RESOURCE PROTECTION AREA (RPA)

ENCROACHMENT EXCEPTION #WAIV-2023-00380

WATER QUALITY IMPACT ASSESSMENT (WQIA) #WQIA-2023-
00020

7819 SOUTHDOWN RD, ALEXANDRIA, VA 22308

Existing Condition Impervious Area Map

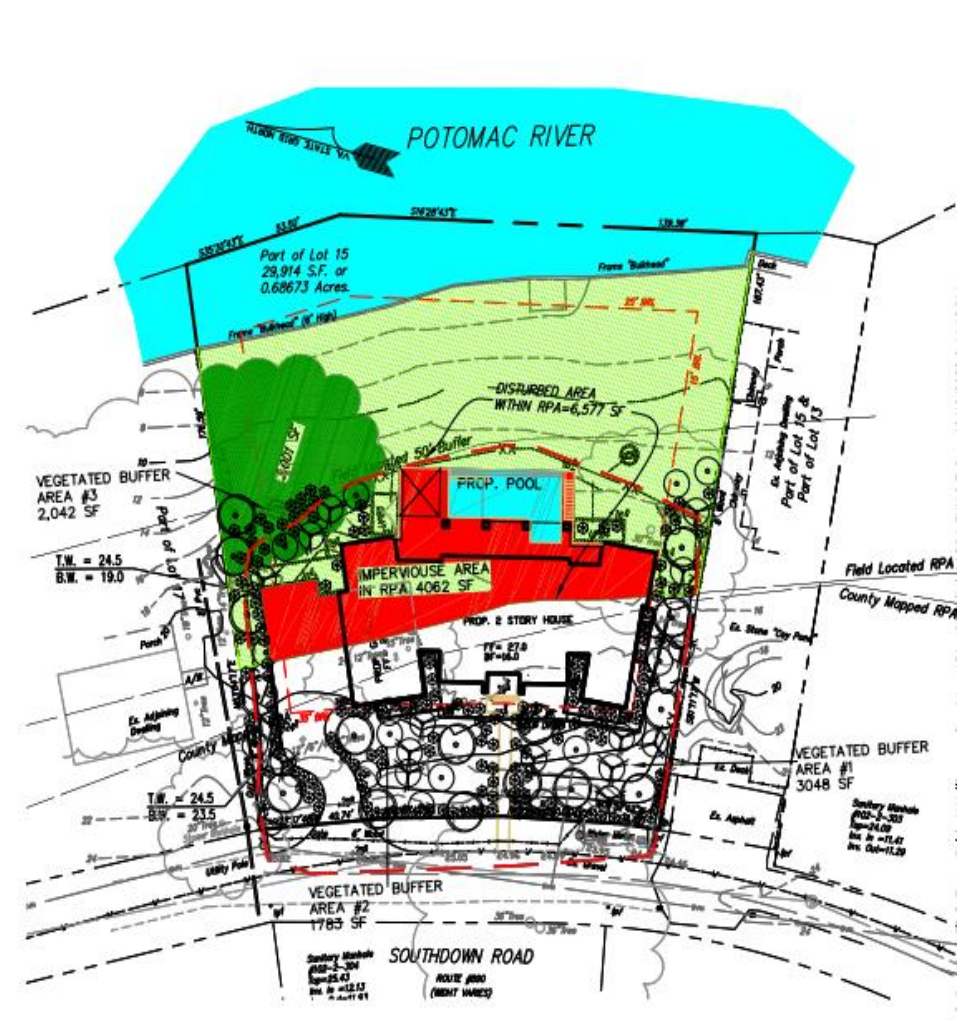
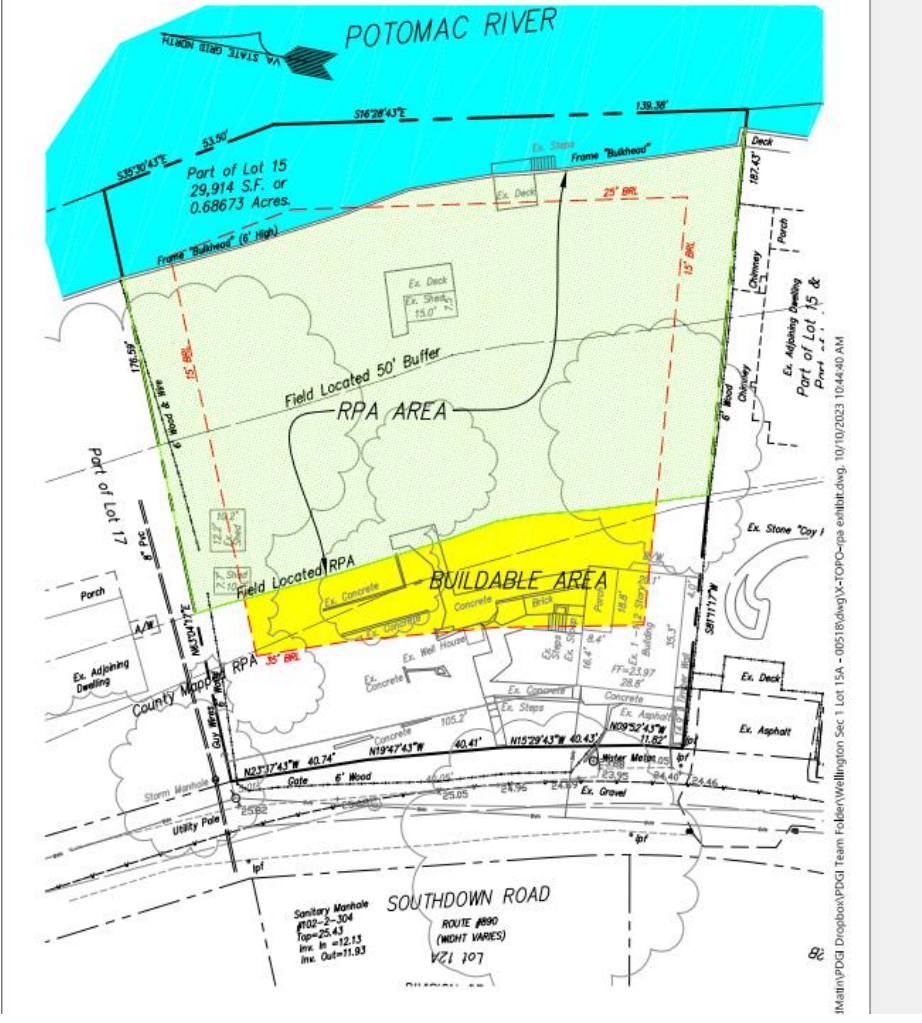
Total impervious area within the RPA at existing condition = 386 sf

Total proposed impervious area within the RPA = 4,062 sf

Net increase in impervious area within the RPA = 3,676 sf
